Re: FCC ID: TR4-A4XG1-2170

Applicant: ADAPT4 LLC.
Correspondence Reference Number: 26659
731 Confirmation Number: TC724842
Date of Original Email from Andrew Leimer: 02/17/2006
Date of Original Response from Adapt4: 03/02/2006

Subject: Adapt4 responses to Mr. Leimer's questions regarding FCC
Equipment Authorization

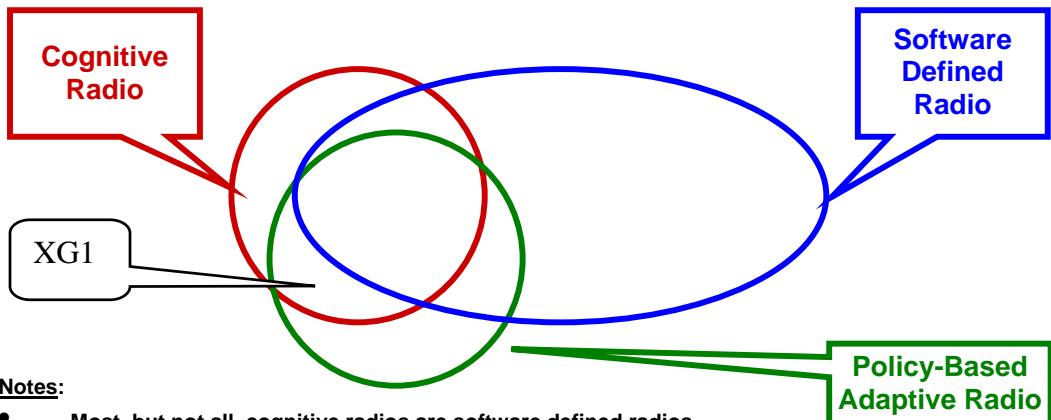
Provide a description of how the license holders in the authorize band under Section 90.259 can benefit from using the channel blocking-out and the spectrum analyzer features of this device and ensure that they operate only on the channels available to them

As an additional layer of protection for primary licensees, the network operator can choose to administratively block out any channels in the authorized band so that they will never be among the "candidate" channels for secondary use; the operator might do this because traffic patterns show that certain of the channels are heavily used.

In addition, the operator can also use the feature to partition the available bandwidth among adjacent networks.

Thirdly, the operator may block channels used by distant networks, improving QoS in marginal situations to reduce interference caused by non XG1 radios.

Fourthly, the operator may block channels within the authorized band to assist with determining the source of an interference complaint. The block-out function further restricts use within the authorized band. (Note: An operator can only block or unblock a channel that is within the authorized band).
